SB-GA8-2006-34

Service Bulletin

Oil cooler front baffle modification

All GA8 serial numbers up to S/N GA8-05-095

Figure 1

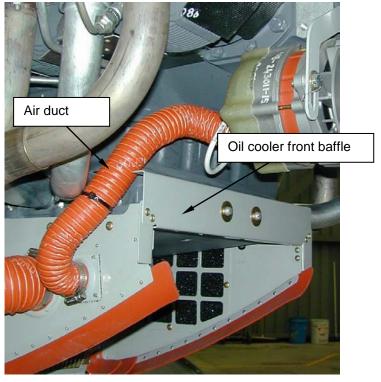
The air duct connecting the alternator shroud to the air intake plenum has been observed on some aircraft to be a tight fit between the engine and the oil cooler front baffle. This service bulletin reworks the oil cooler front baffle to give additional clearance for the air duct. Alternatively a new revised oil cooler front baffle may be installed.

- 1.1 Remove upper and lower cowls to gain access to the oil cooler front baffle. Refer to Figure 1.
- 1.2 Remove the oil cooler front baffle from the air intake assembly.
- 1.3 Taper the right hand end of the top flange of the oil cooler front baffle to provide additional clearance to the air duct. The maximum permitted length of the taper is 2.0". Refer to Figure 2.
- 1.4 Prime the trimmed edge with a suitable primer, such as zinc chromate primer.
- 1.5 Replace the oil cooler front baffle.
- 1.6 Refit cowls.

- 2.1 Remove upper and lower cowls to gain access to the oil cooler front baffle. Refer to Figure 1.
- 2.2 Remove the existing oil cooler front baffle from the air intake plenum.
- 2.3 Install new oil cooler front baffle.
- 2.4 Refit cowls.
